ADDENDUM NUMBER 1

O'DONNELL PARK
PARKING STRUCTURE FACADE IMPROVEMENTS
Site #784, Bldg. #75
910 East Michigan Street
Milwaukee, WI 53202

Project Number: O114-11415-2

Date of Addendum: March 7, 2011

WISCONSIN AVENUE LEVEL
PLAN - SECTOR 2

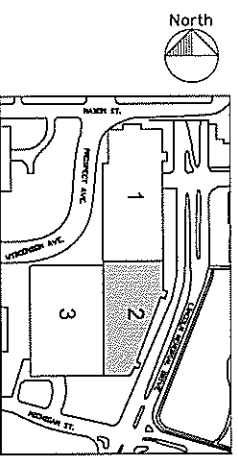
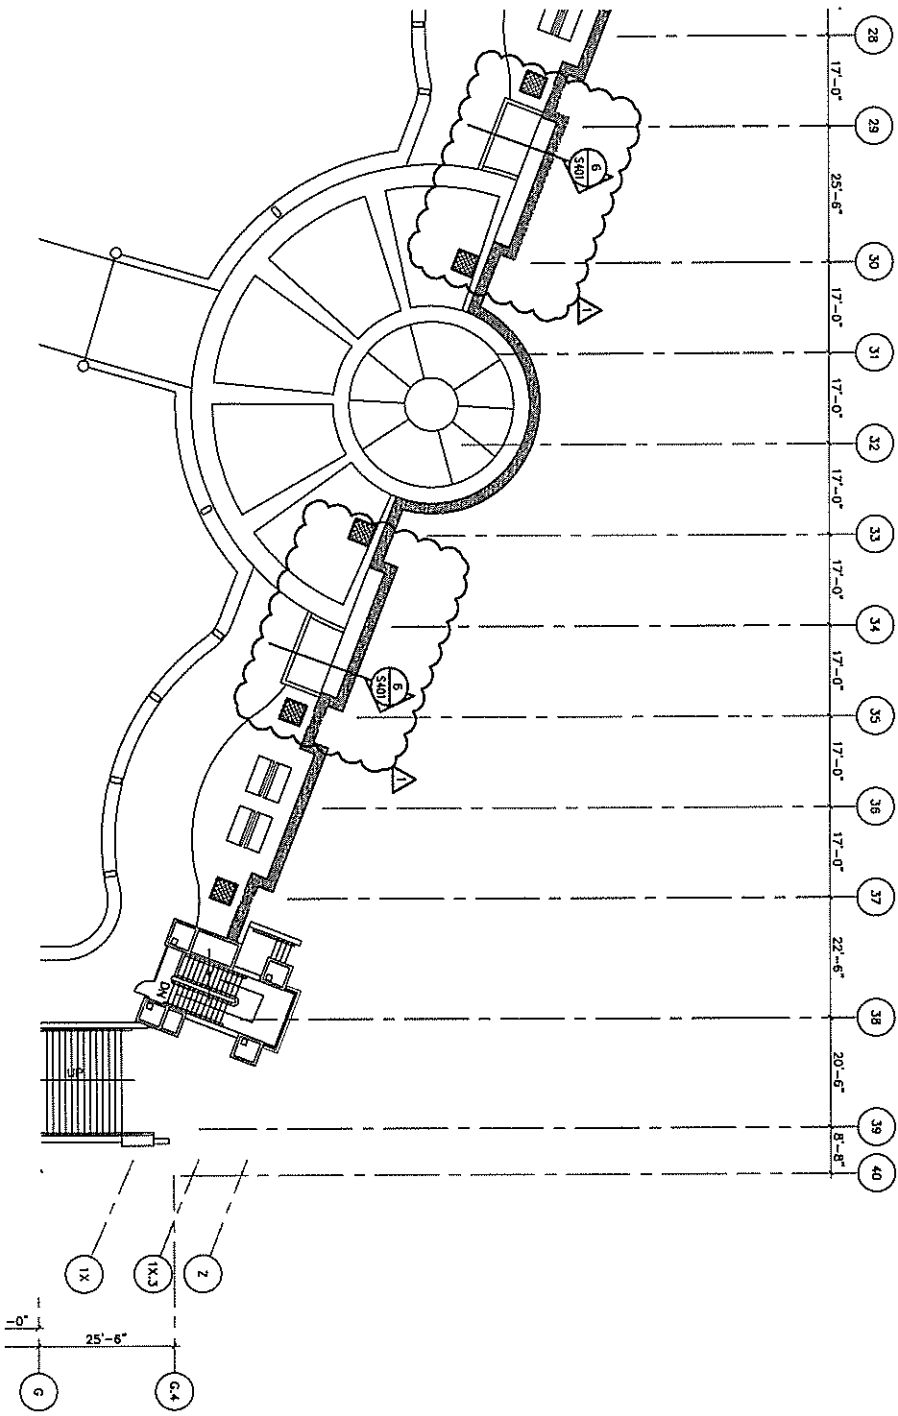
REVISE the plaza parapet layout to include lookouts between Column Lines 29-30 and 33-35, and add light pole bases at Columns Lines 30 and 33, per the attached revised partial plan drawing.
